ADDENDUM NO. 02

September 30, 2026

Trumbull Metropolitan Housing Authority
Hubbard Manor Interior Renovation
TC Project No.: 2261013

1 D101 DEMOLITION 1ST FLOOR PLAN
SCALE 1/8"=1'-0"

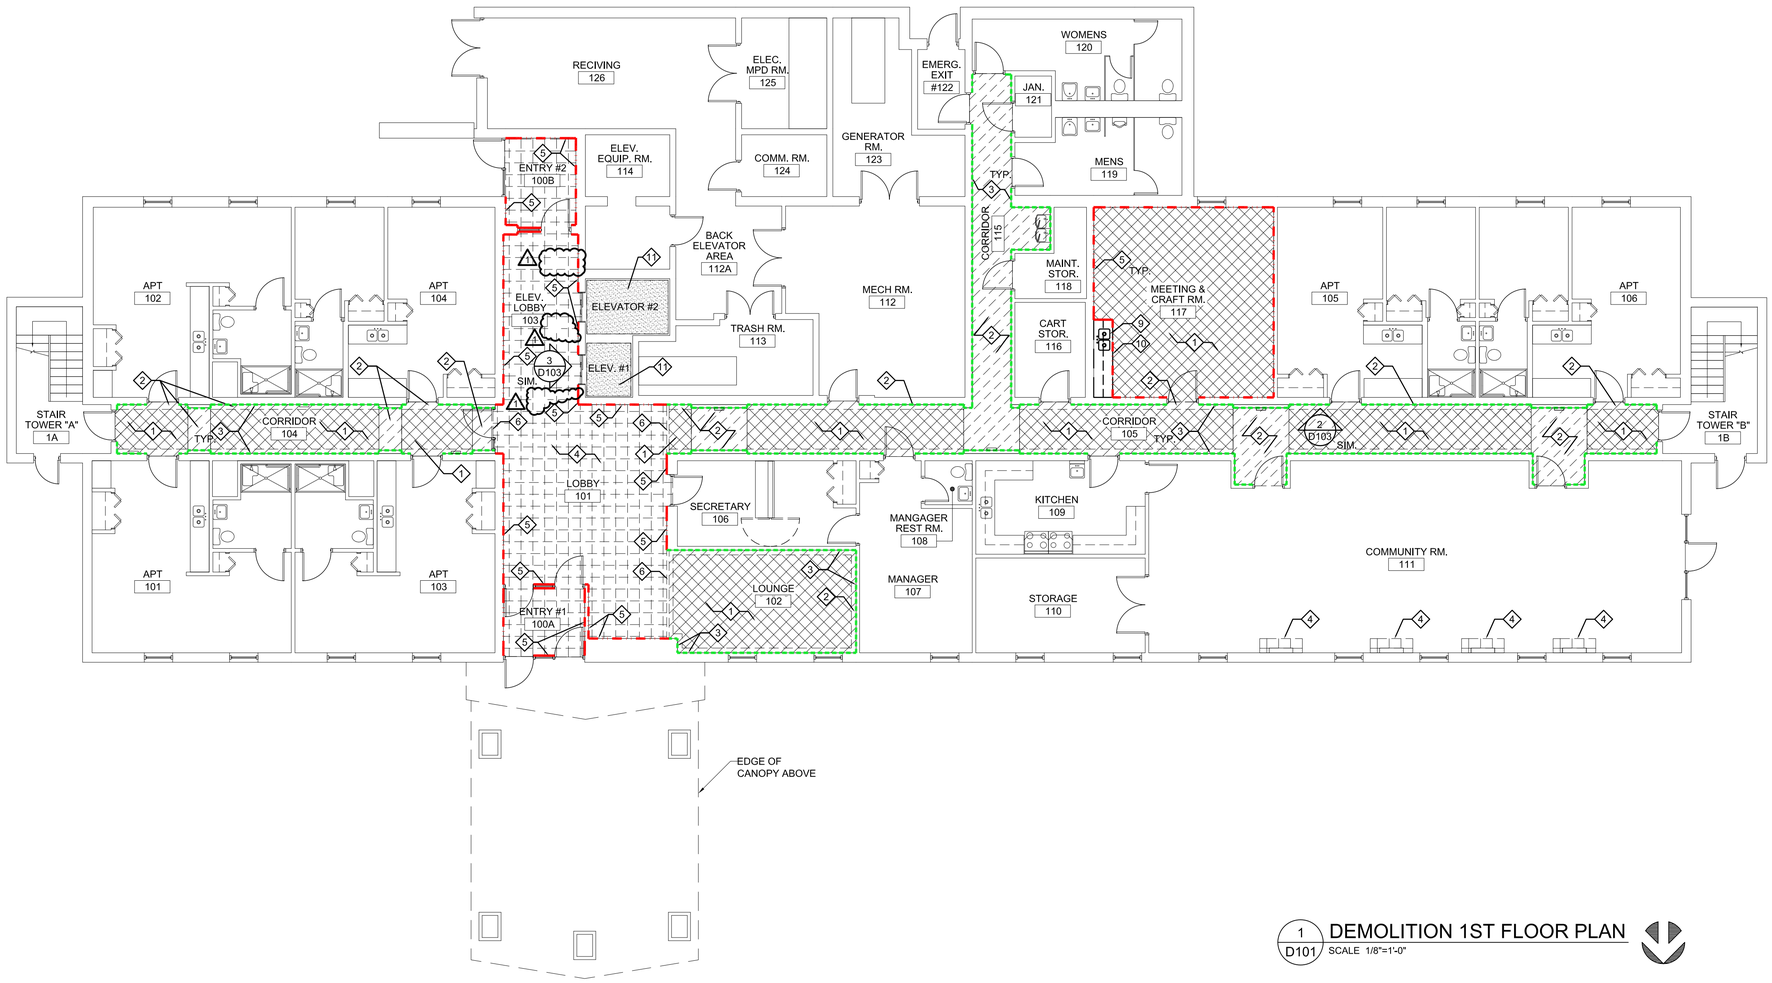
1. A103, revised to add plastic laminate detail.
2. D101, revised to omit removal of plastic laminate panel at elevator wall.
3. D102, revised to omit removal of plastic laminate panel at elevator wall.
4. D103, revised to omit removal of plastic laminate panel at elevator wall.

3 / D103 TYPICAL DEMO ELEVATOR ELEVATION
SCALE 3/8"=1'-0"

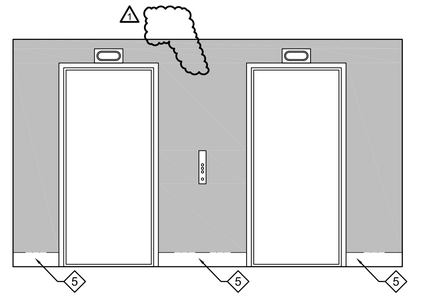
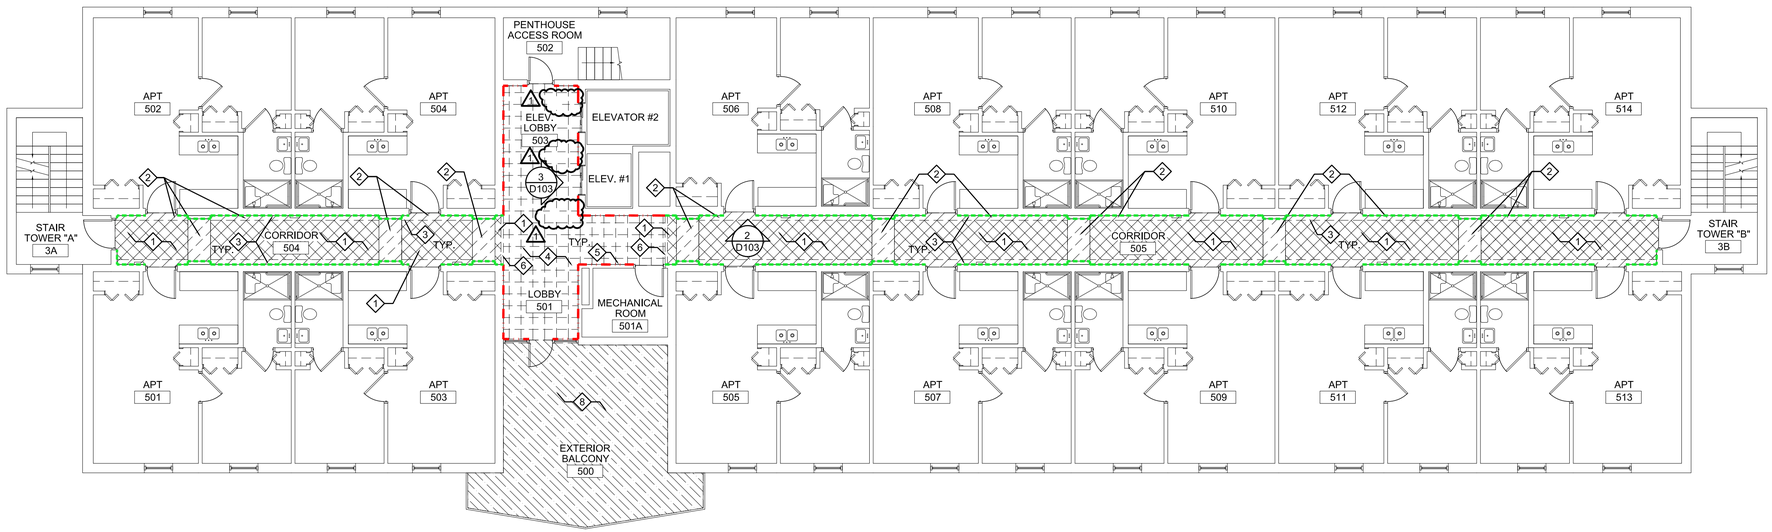
3. Please confirm the intended substrate and installation method for the new laminate. If the existing laminate is in good condition, securely bonded, flat, and otherwise suitable as a substrate, is the new laminate intended to be installed directly over the existing laminate after proper cleaning, deglossing/sanding, and surface preparation? Alternatively, should the existing laminate be removed prior to installation, or should a new backer/substrate be installed over the existing surface prior to applying the new laminate?
   Response: The existing laminate can remain in place if securely bonded and in good condition, with new laminate installed on top after proper surface preparation.
